GW - 40

**SOIL AND
GROUND WATER INVESTIGATIONS
AND REMEDIAL ACTION PLAN**

**GIANT INDUSTRIES, INC.
BLOOMFIELD REFINERY
BLOOMFIELD, NEW MEXICO**

June 1987

FIGURE 6-2

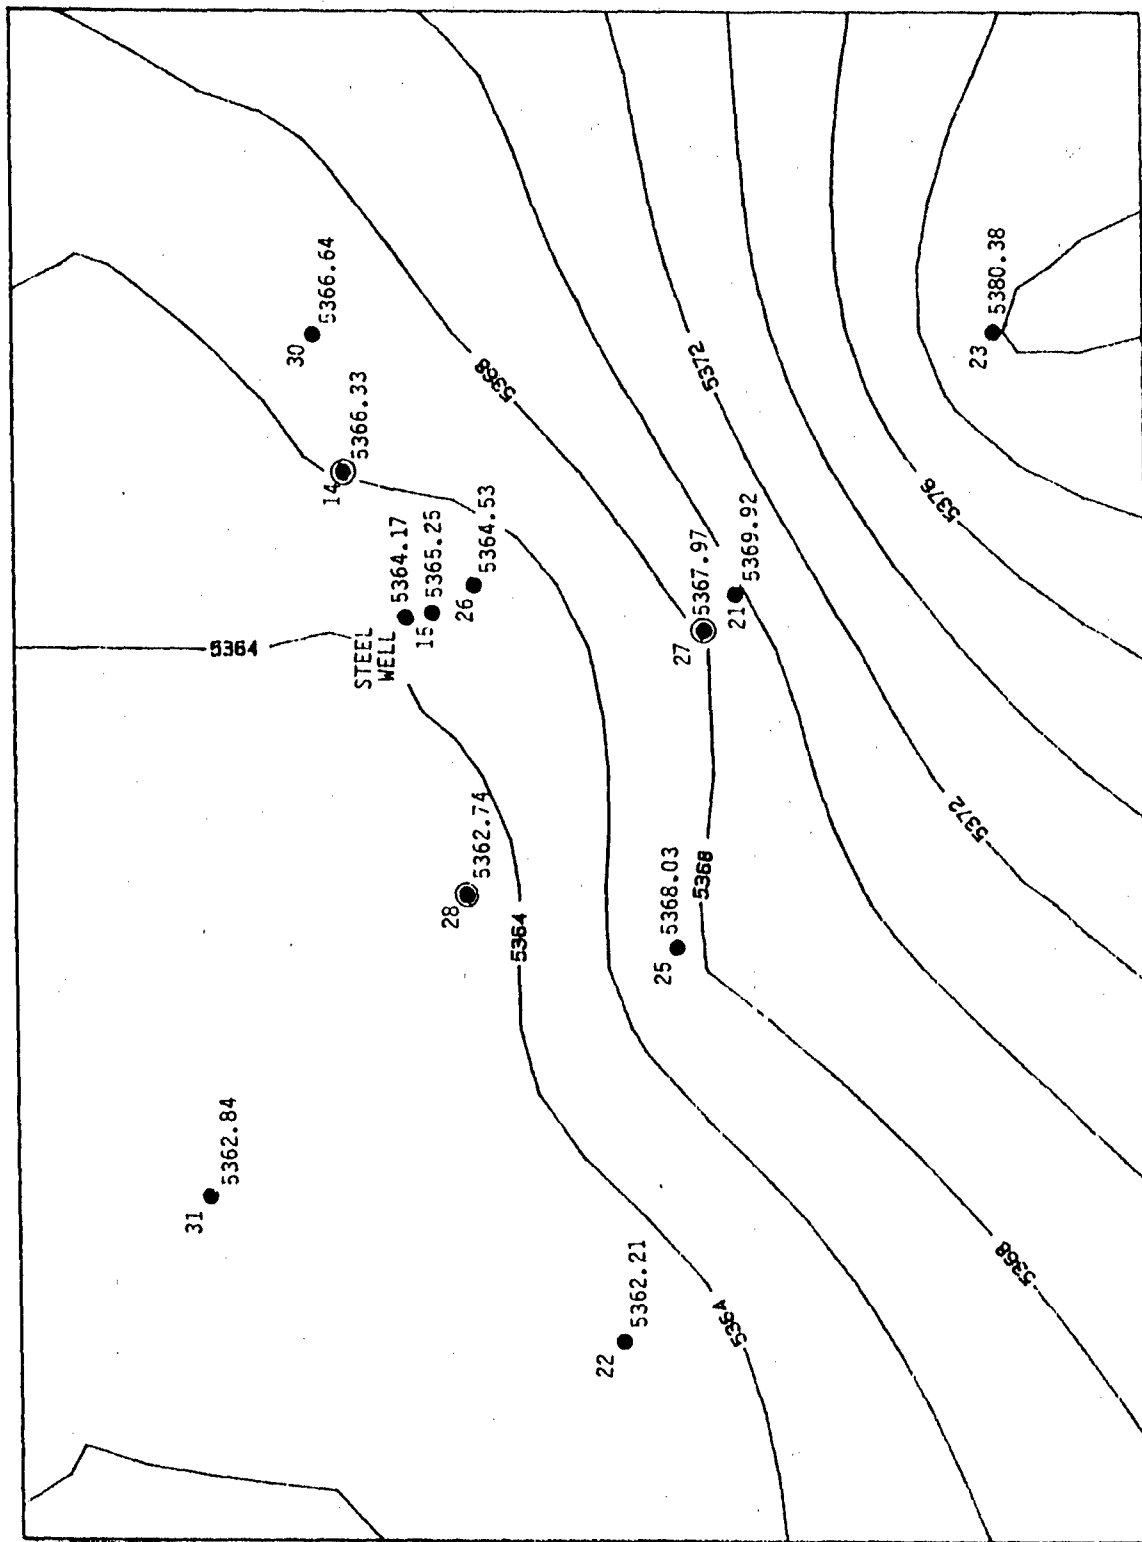
yeh!
same
computer
drew both!

FIGURE 6-3

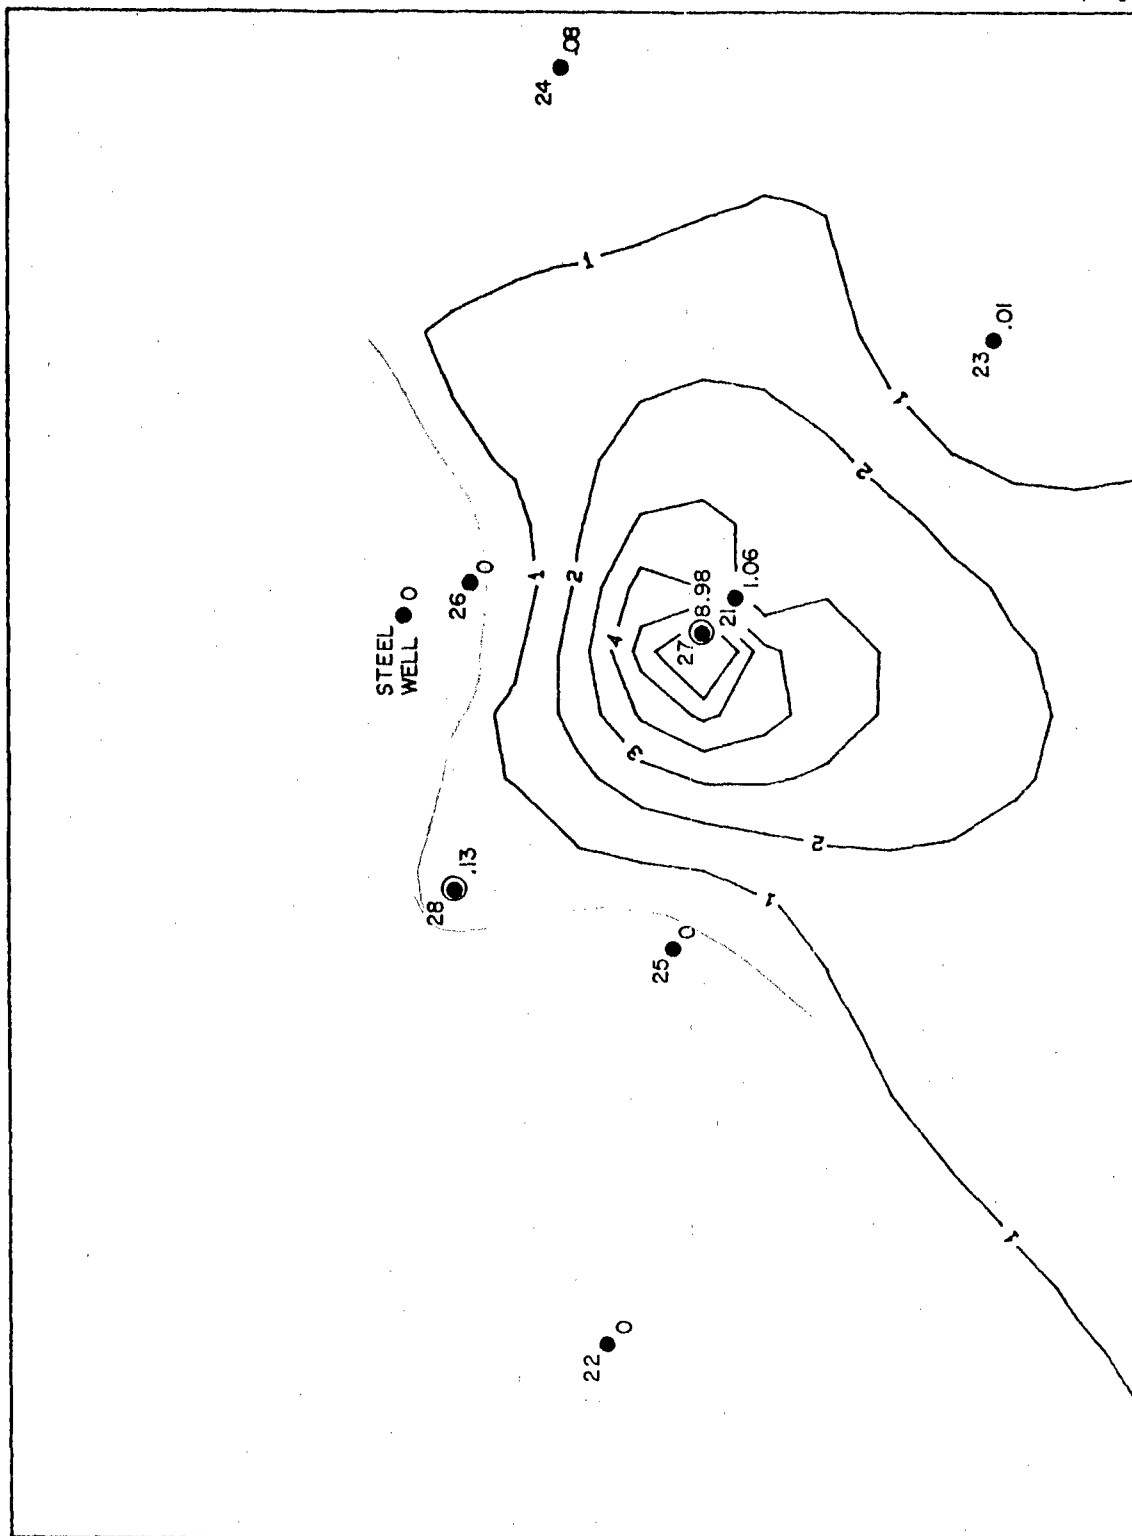
GROUND WATER LEVEL CONTOUR MAP - DIESEL SPILL AREA
(BEFORE PUMPING BEGAN) *Date?*
5/30/86

FIGURE 6-6

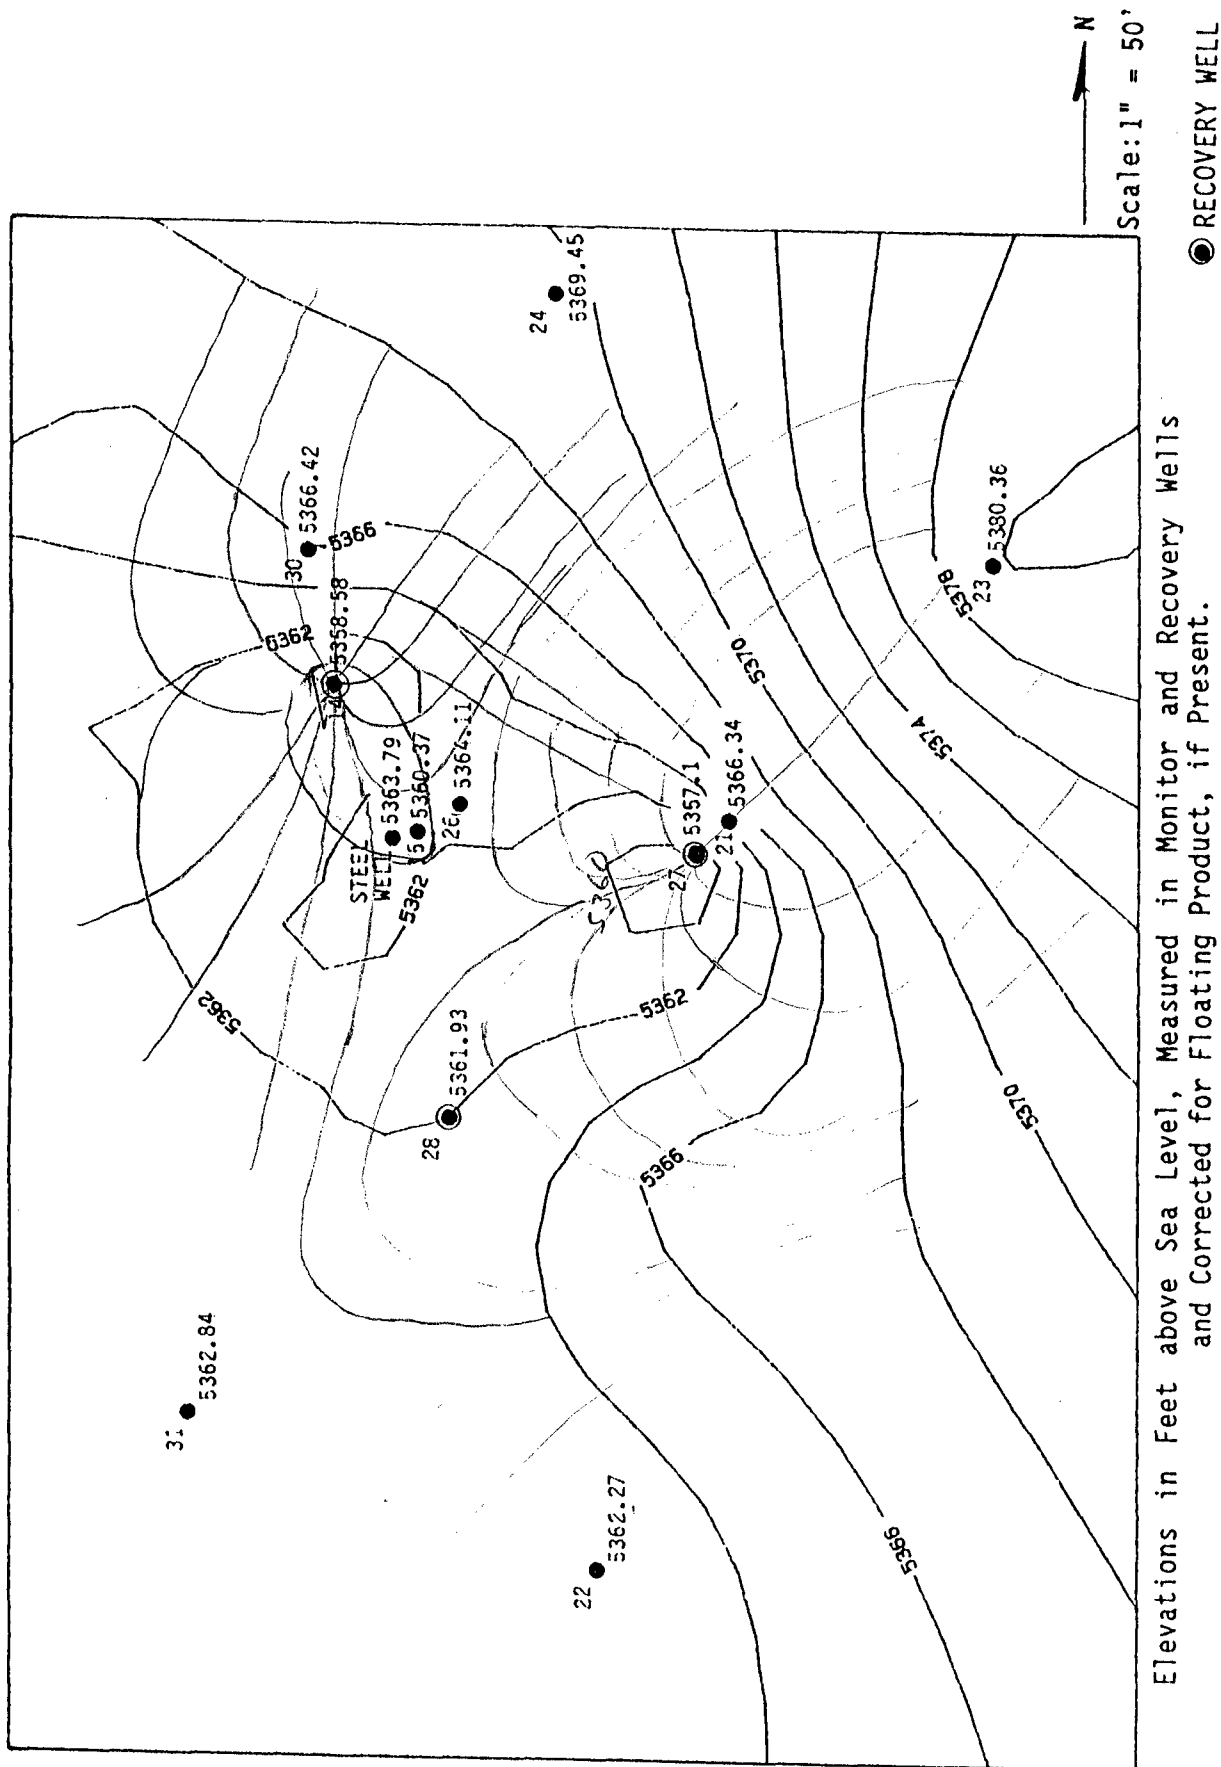
why increase
product in
wells not
previously contain?
eq. 26-30

FIGURE 8-4

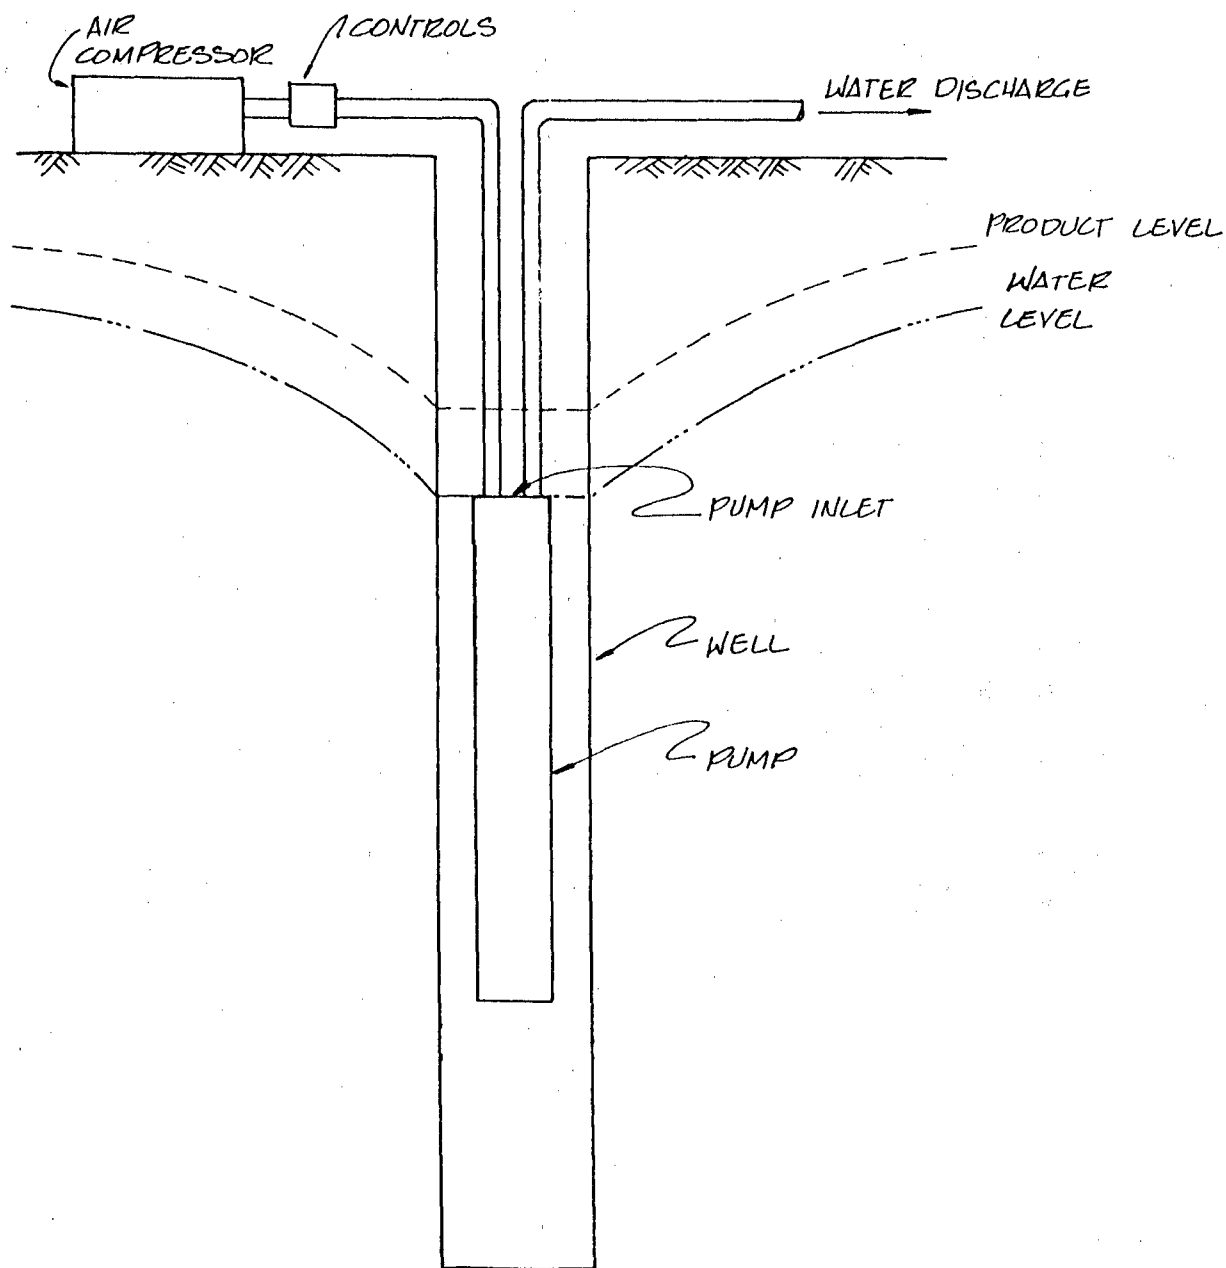
*Model may
not be
calibrated
right
It's are
incorrect*

FIGURE 8-5

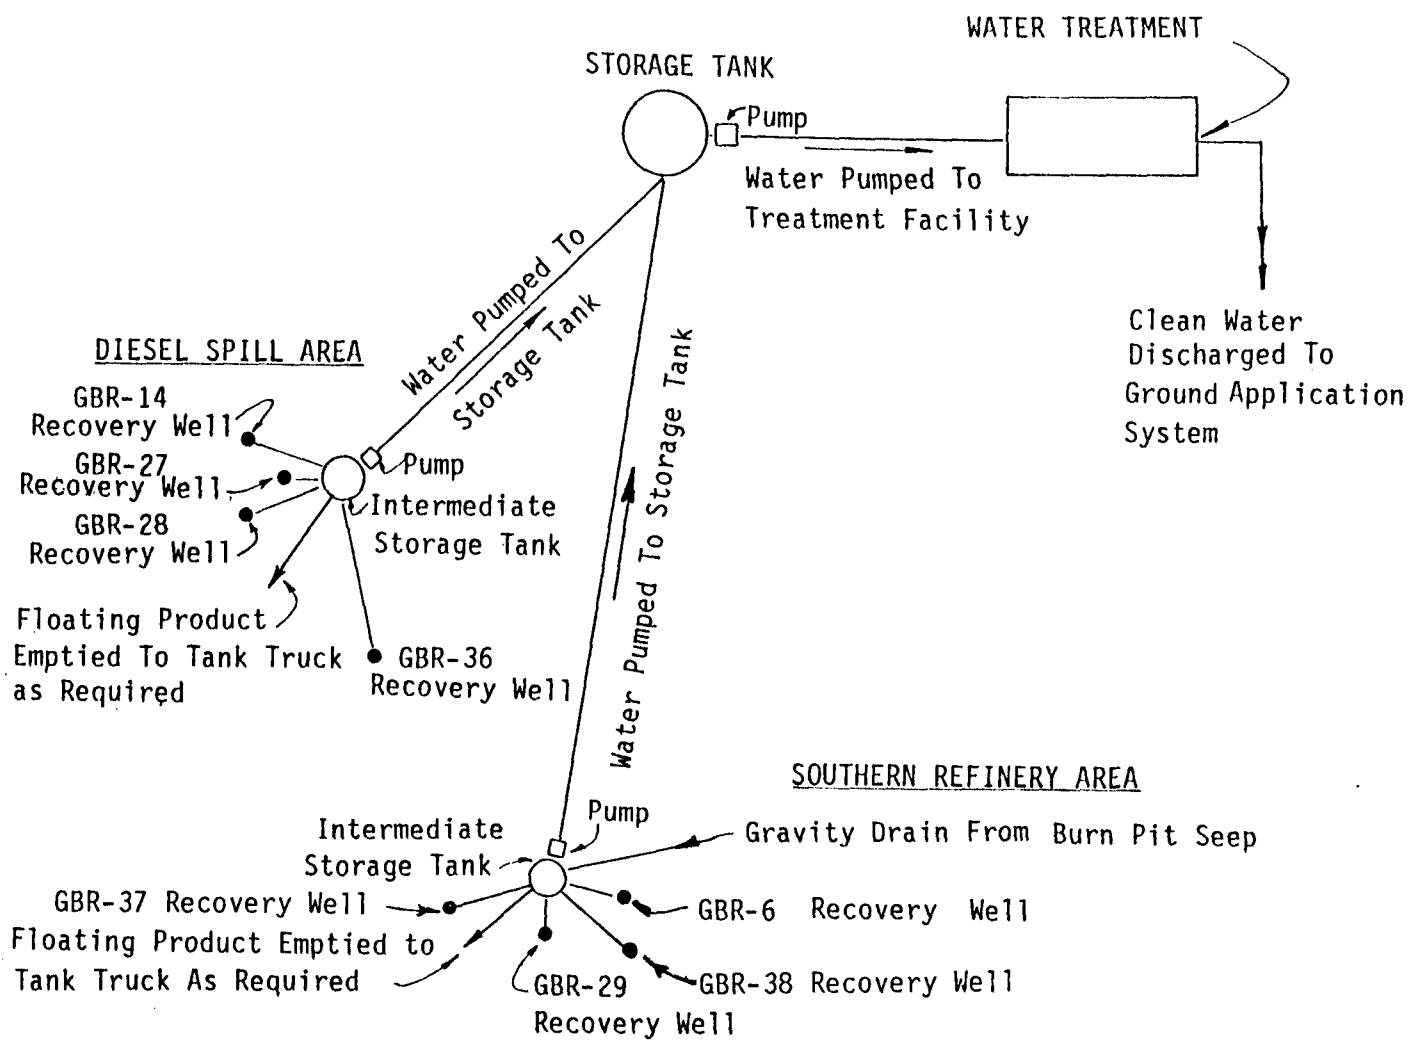
where located? Need to be on plate 1

FIGURE 10

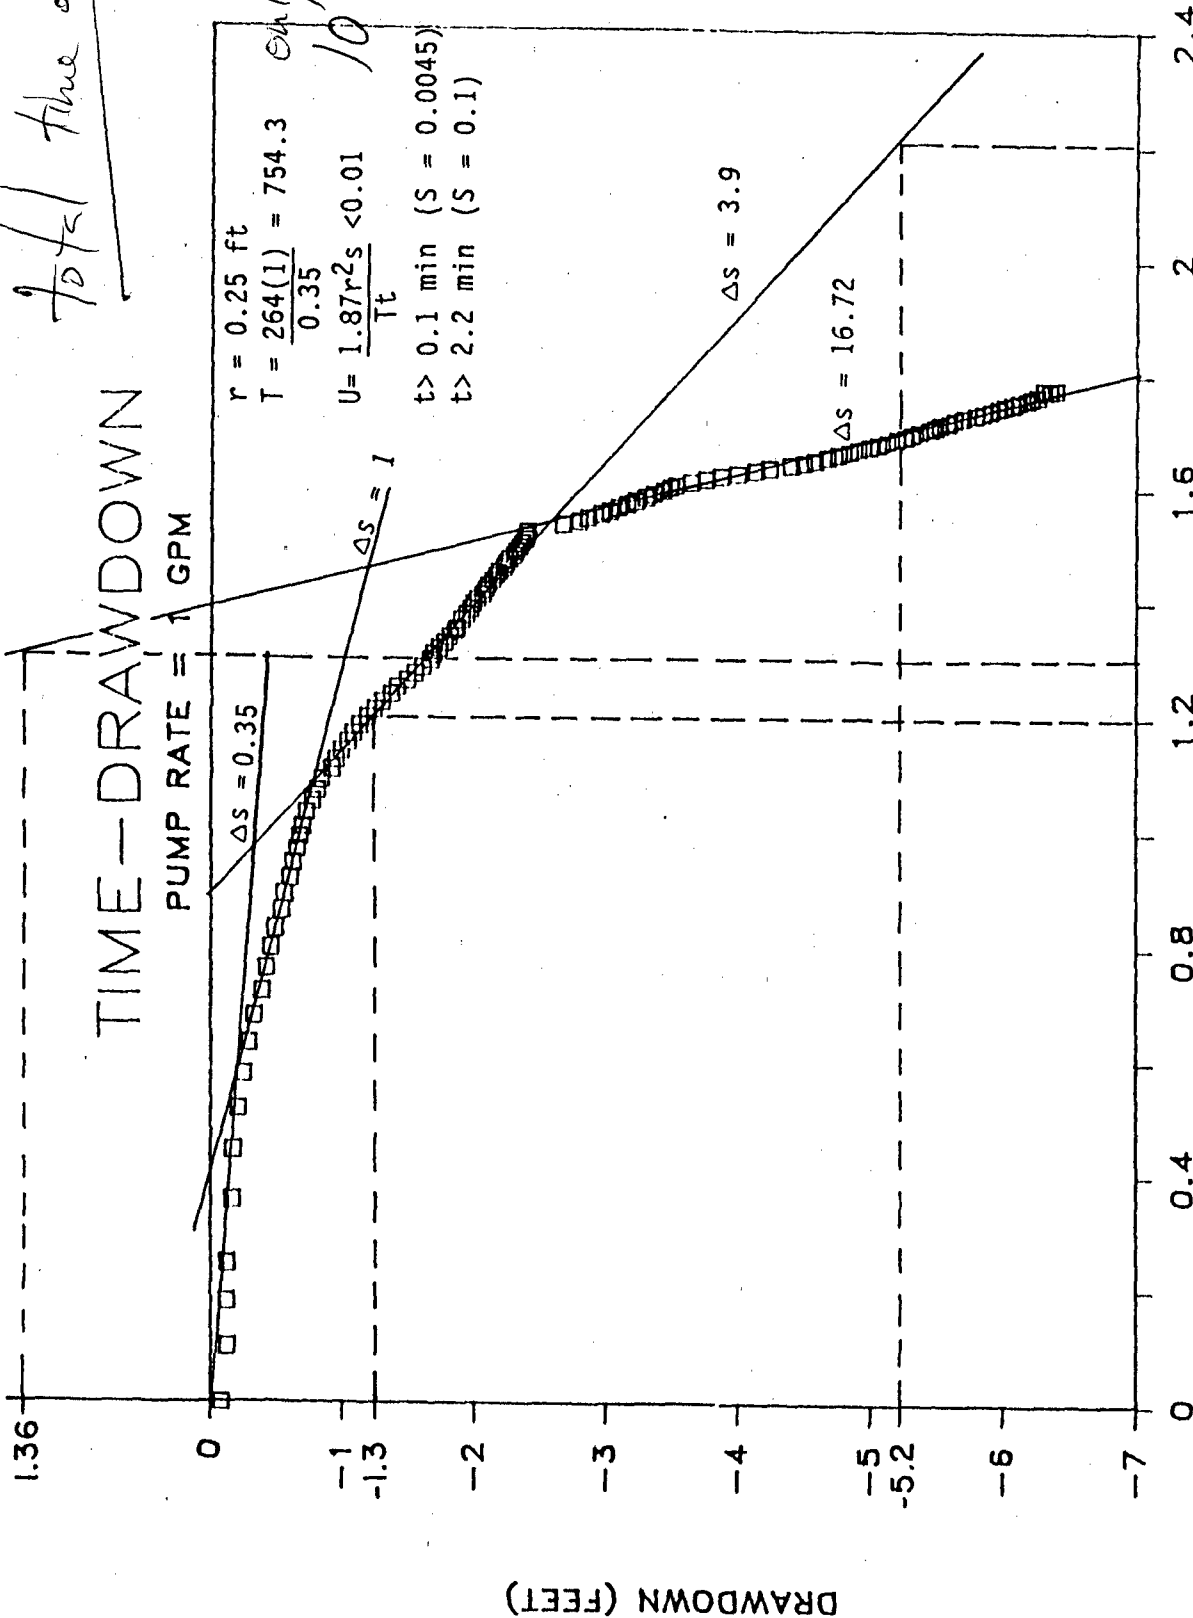
only uses 10 min of data
